SERVICE BULLETIN

NO. A2898-71-1

POWER PLANT - FAN COWLING - HOLD OPEN ROD REPLACEMENT OF SECONDARY LOCK

FIGURE 1 - A2898-1 STRUT ASSEMBLY
EXPLODED VIEW

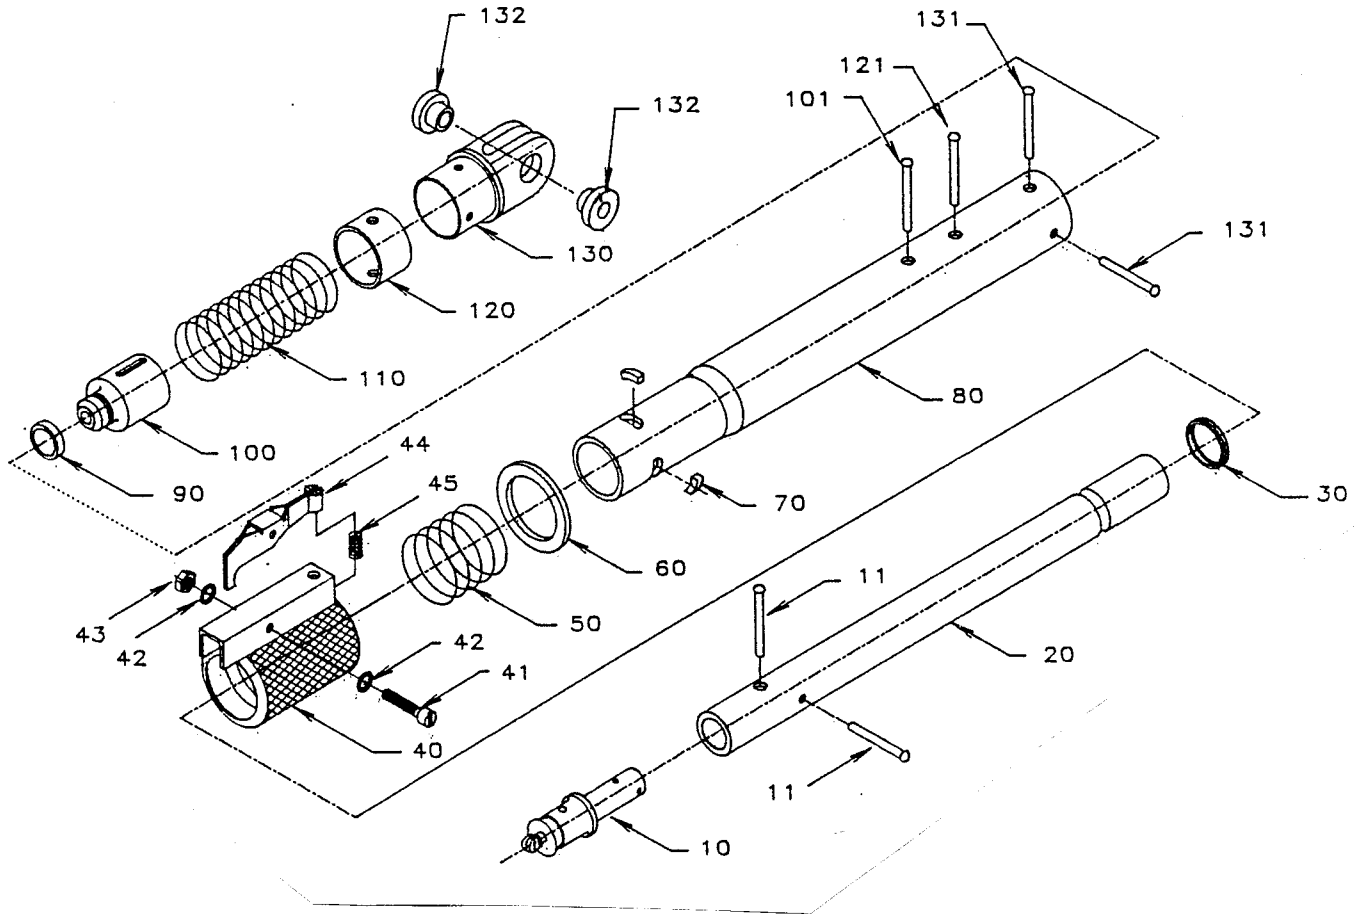
The incorporation of this Service Bulletin will replace the secondary lock with a locking pin to prevent inadvertent unlocking of the hold open rod in the extended and locked position.

A. Disassembly (See Figure 1)

- (1) Remove secondary lock housing from collar (40) by breaking six spot welds along two sides of rectangular housing. Use a hammer and chisel to break welds. Remove sharp edges on broken welds. Scrap housing, safety latch (44, 43, 42, 41), and spring (45).
- (2) Drill out two rivets (131) using a 0.125 inch (3.175 mm) diameter drill. Remove end fitting (130).
- (3) Drill out two rivets (121) and (101) using a 0.156 inch (3.962 mm) diameter drill. Remove plug (120) spring (110) and damper (100) from end of outer tube (80). Check "O" ring (90) for cuts and wear. Replace if worn or cut.

FIGURE 2 - LOCKING PIN ASSEMBLY
EXPLODED VIEW

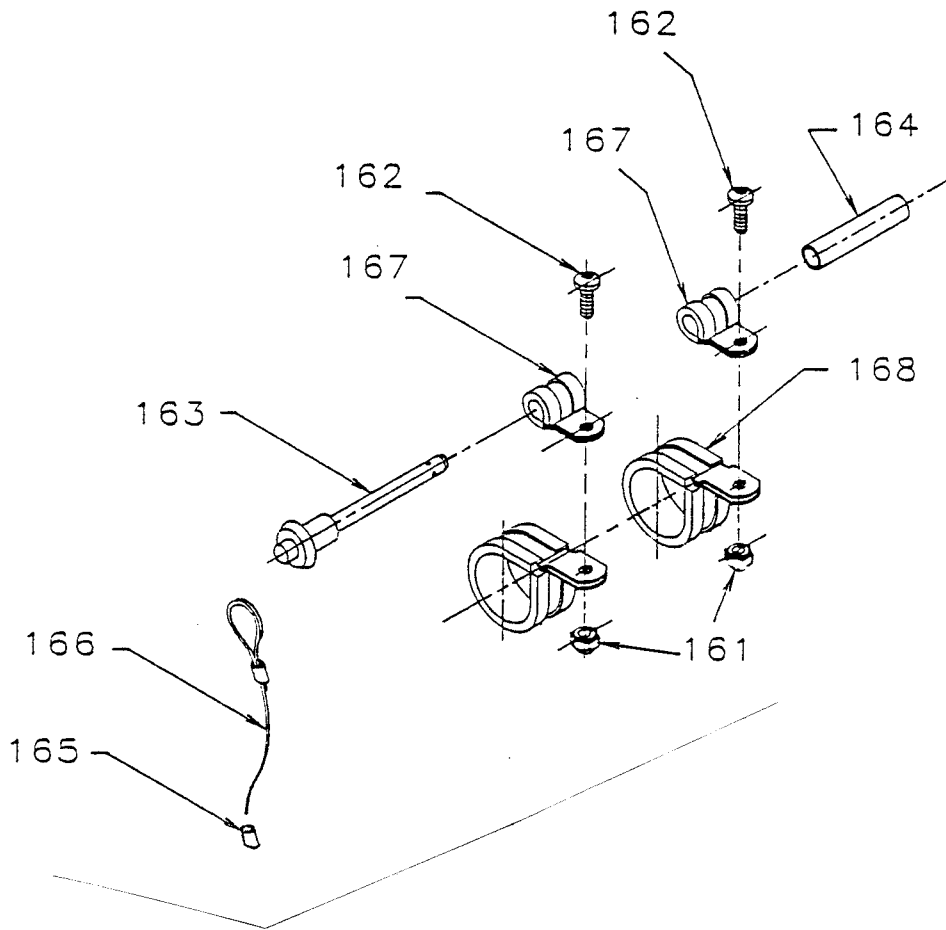
B. Assembly (See Figures 1 and 2)

- (6) To assemble the secondary locking pin (163), place the end of the cable assembly (166) over one large cushioned clamp (168). Slip the cushioned clamp (168) with cable assembly (166) over the rod end of the outer tube (80). Position the edge of the cushioned clamp (168) 0.750 inch (19.05 mm) from the center of the 0.250 inch (6.35 mm) hole in the outer tube. Slip the second cushioned clamp (168) over the end of the outer tube (80) and position the outer edges of the clamps (168) 1.25 inches (31.7 mm) apart. Attached the small cushioned clamps (167) to the large cushioned clamps (168) with bolts (162) and nuts (161). Align holes in small cushioned clamps (167) by inserting pin retainer (164) prior to tightening bolts (162) and nuts (161).

- (7) Secure locking pin (163) to cable assembly (166) with ferrule (165). Check for satisfactory operation of secondary locking pin (163) by extending hold open rod to its locked position and inserting locking pin in 0.250 inch (6.35 mm) hole in outer tube (80).

FIGURE 3 - LOCKING PIN ASSEMBLY

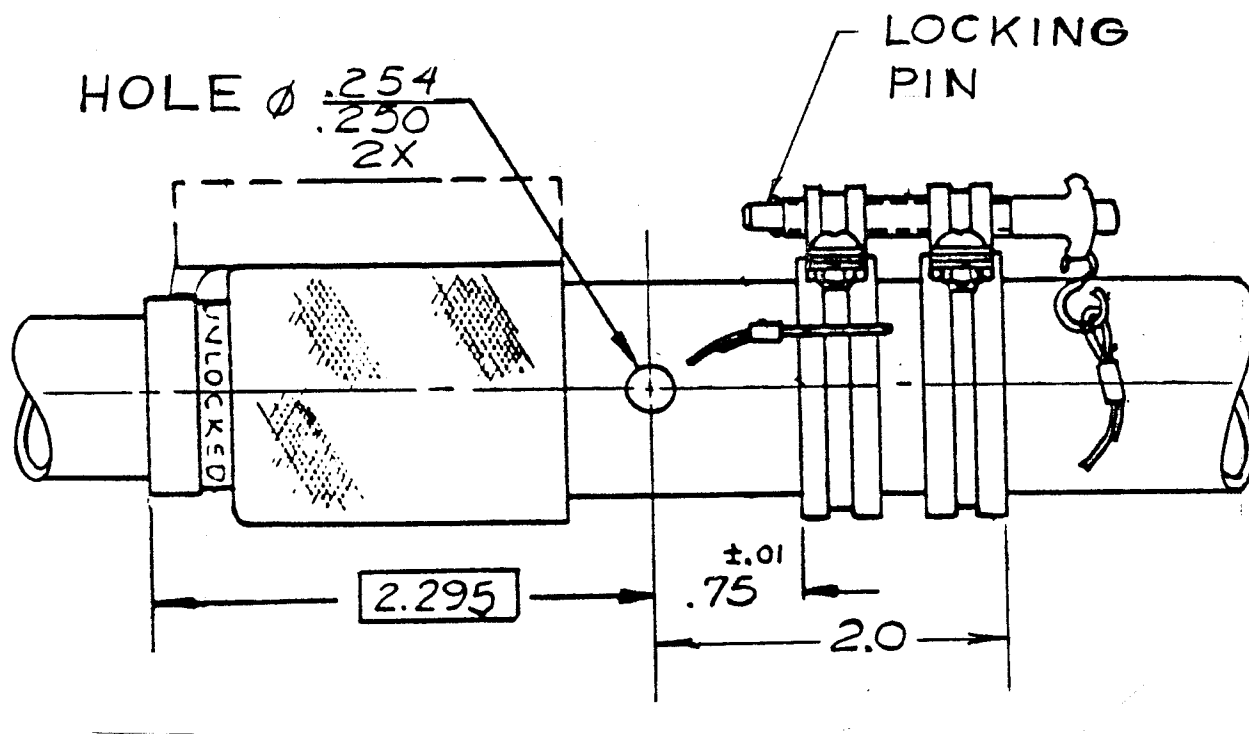
- (1) Extend strut to its fully extended and locked position. Locate hole for locking pin at 2.295 inches (58.29 mm) from face of outer tube (80) as shown in figure 3.
- (2) Drill 0.250 inch (6.35 mm) diameter hole through both sides of outer tube (80). Deburr edges of holes and completely remove metal chips from inside of outer tube (80).

CAUTION: METAL CHIPS LEFT INSIDE THE OUTER TUBE (80) WILL CAUSE SEVERE DAMAGE.
